Addendum to IFB

IFB NUMBER: IFB 24-062/MR
IFB TITLE: Jefferson County Diversion Center Renovation
IFB DUE BY: 11:00 am CT, Wednesday, November 13, 2024
ADDENDUM NO.: 1
ISSUED (DATE): November 1, 2024

ADDENDUM # 01

IFB 24-062/MR Jefferson County Diversion Center Renovation

1 PLUMBING ROOF PLAN
1/8" = 1'-0"

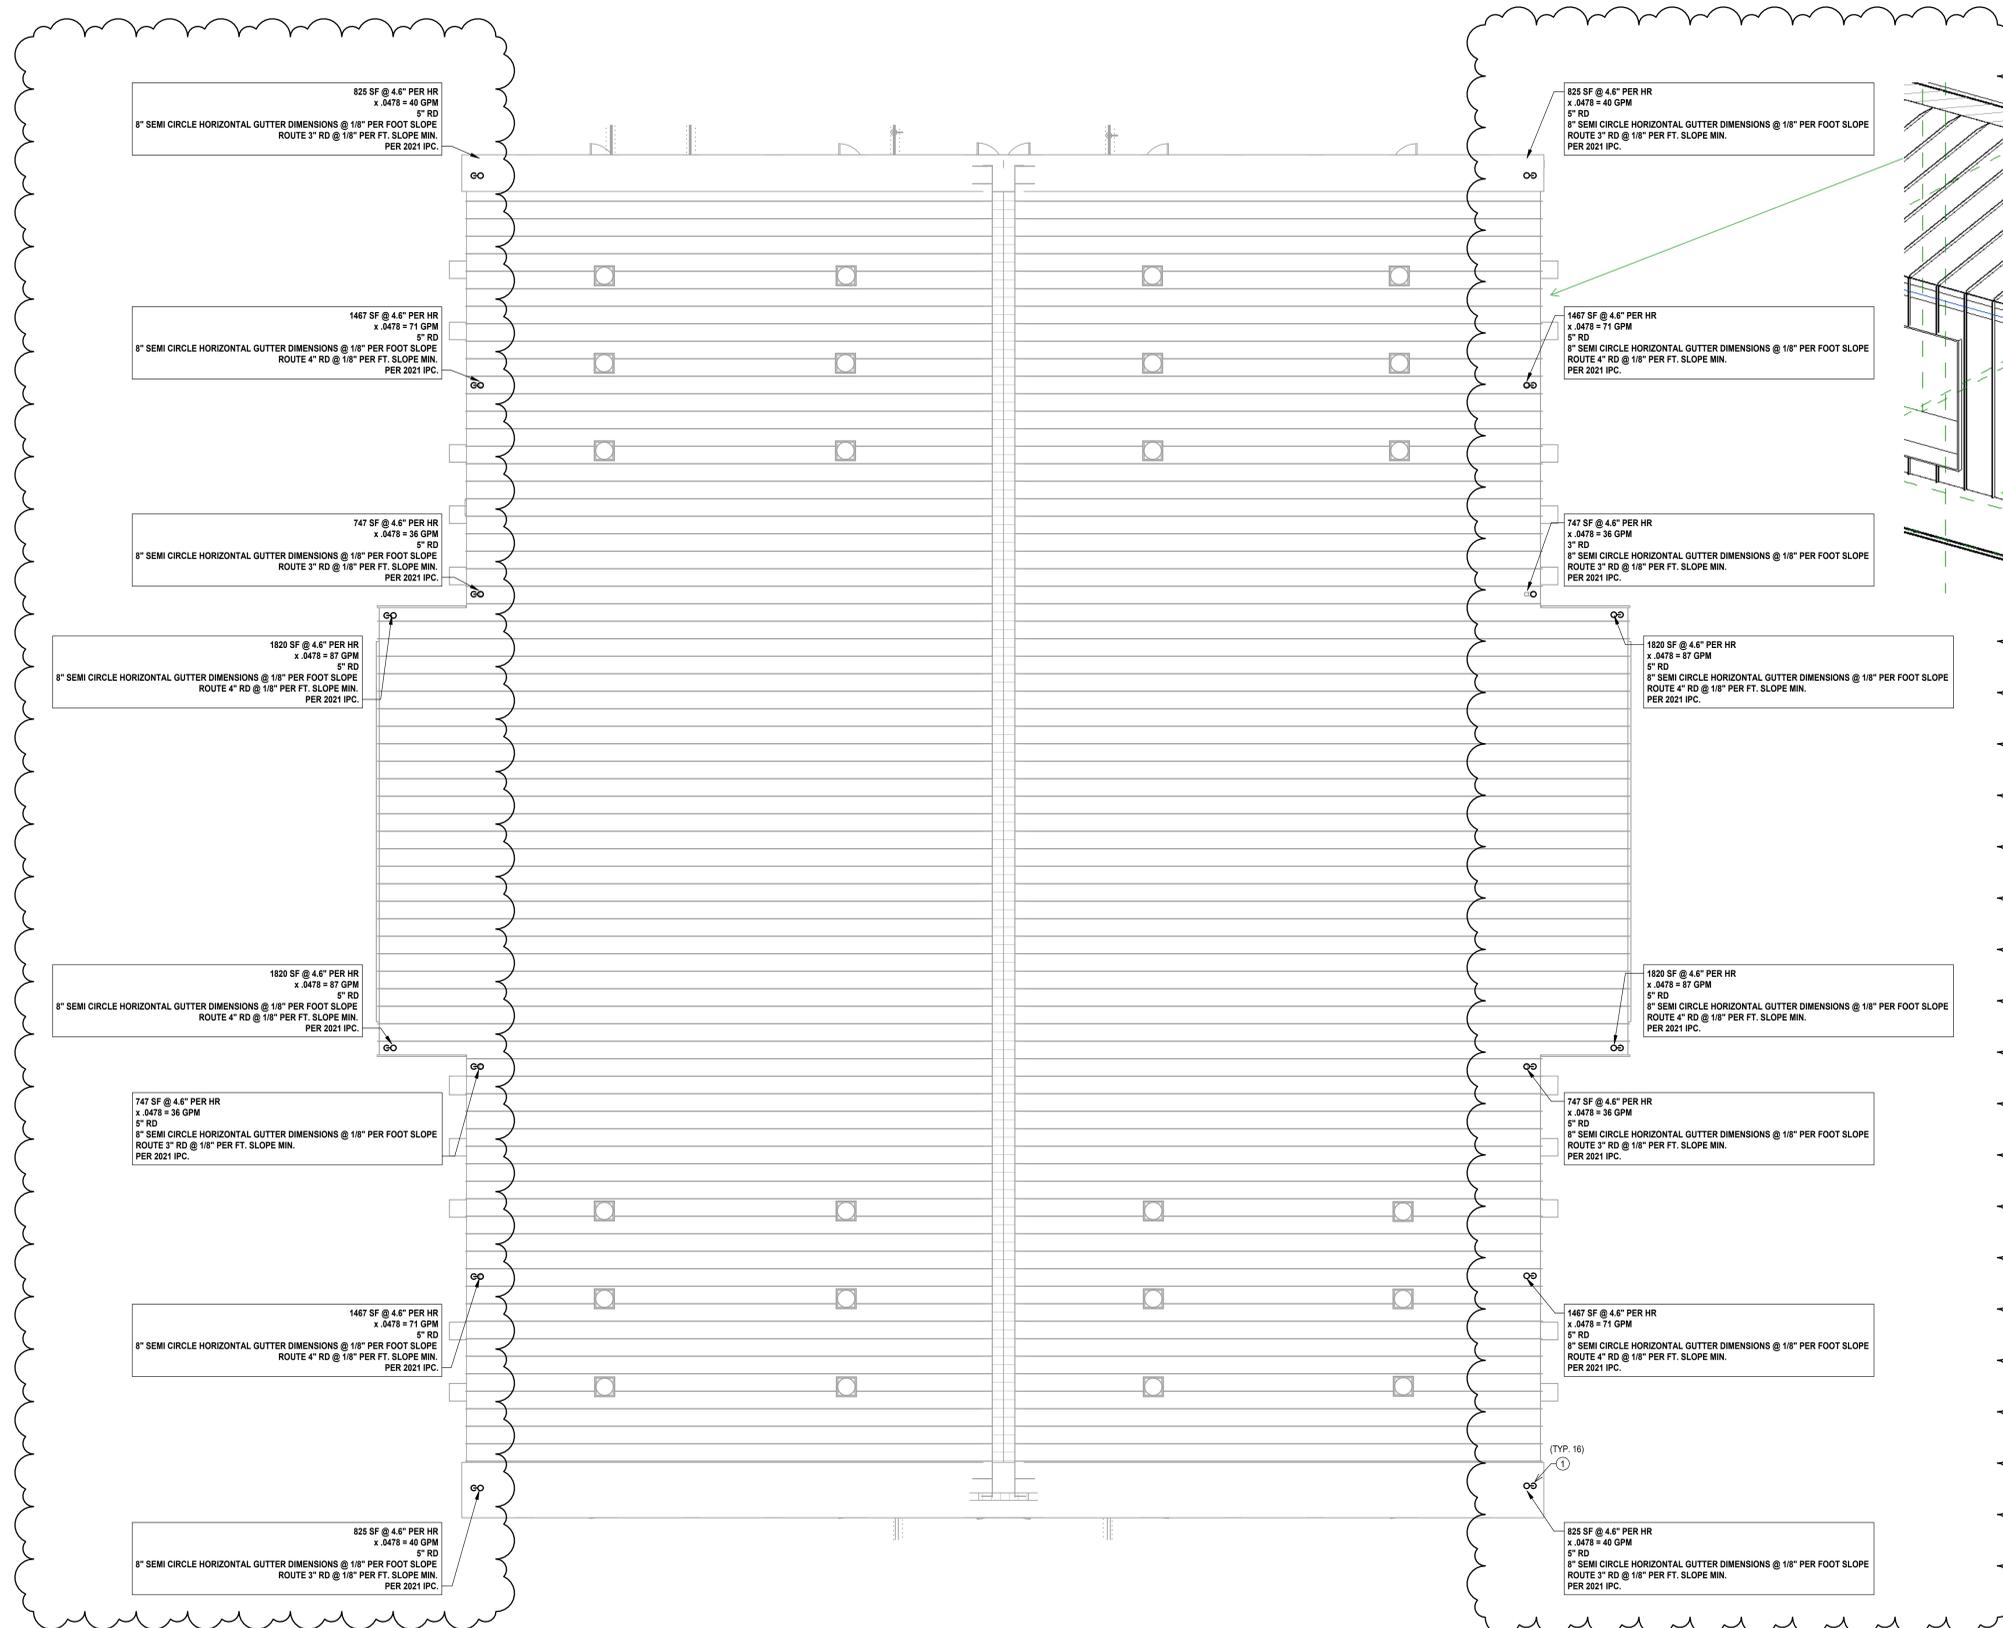
Roof drain information added.
